**Commonwealth Edison**  
1400 Opus Place  
Downers Grove, Illinois 60515

Subject: Zion Station Units 1 and 2  
Control Room Habitability  
NRC Docket Nos. 50-295 and 50-304

ATTACHMENT A  
ADDITIONAL SITE SPECIFIC INFORMATION

PLAN VIEW SKETCH

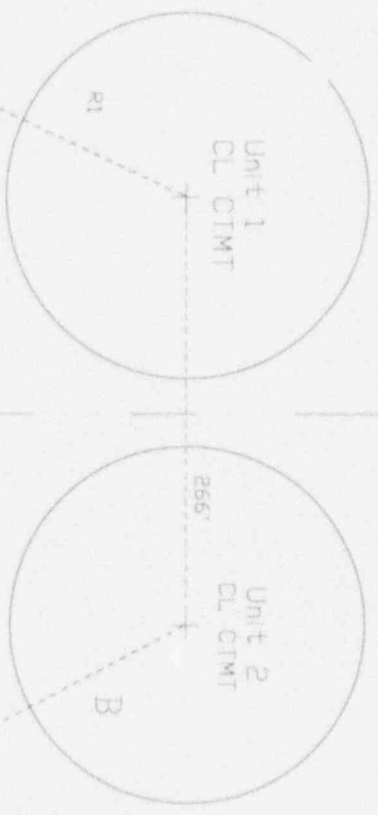
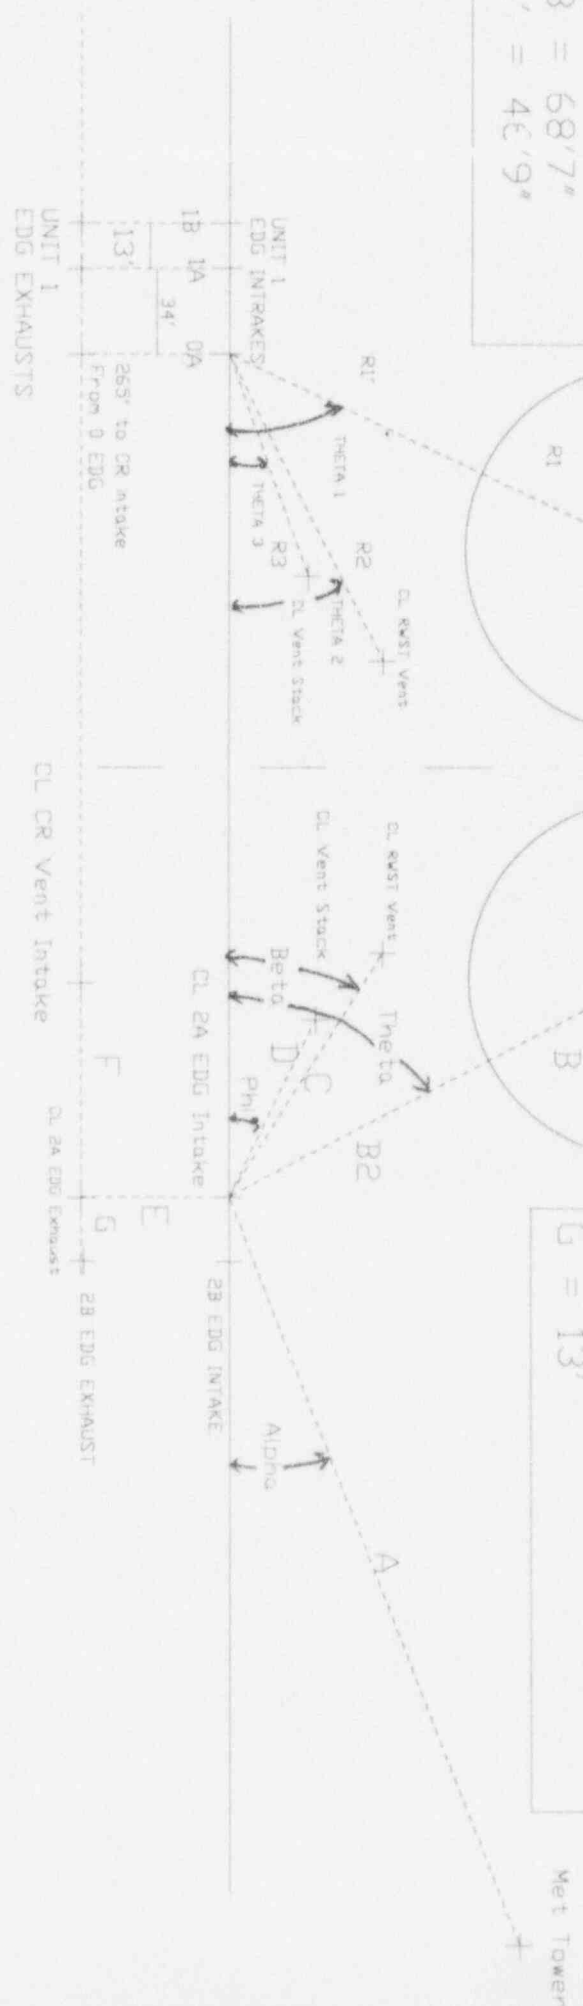
- 2b. Provide, in terms of distance and degrees true, the locations of the meteorological towers from the intakes and release points in Item 1.a above.

- 2c. Based on the Control Room Habitability study, it appears that the EDG air intake is west of the Unit 2 vent and the containment release points, but that winds from the east off the lake were not considered in the study. This interpretation, if correct, would minimize the concentrations at the EDG air intake. Is this interpretation correct? Specify at which unit a LOCA would result in the lower concentrations at the EDG air intake.

The meteorological tower location is approximately 2000' from the EDG intake at an angle of 37.4° from the east west Base Line shifted to be along the EDG intake wall. The enclosed sketch illustrates the location of the tower.

The EDG air Intake is actually east of the Unit 2 Containment. Therefore, the interpretation appears to be incorrect. A LOCA on Unit 1 is expected to result in lower concentrations at the 2A EDG intake since it is further away than Unit 2. For the Analysis, the Unit 2 LOCA was considered since its source was closest to the Control Room Emergency Intake which is located on the Unit 2 side of the turbine building. The flowpath from the containment to the Unit 2A EDG was the closest intake relative to the Control Room Intake and the Unit 2 Containment.
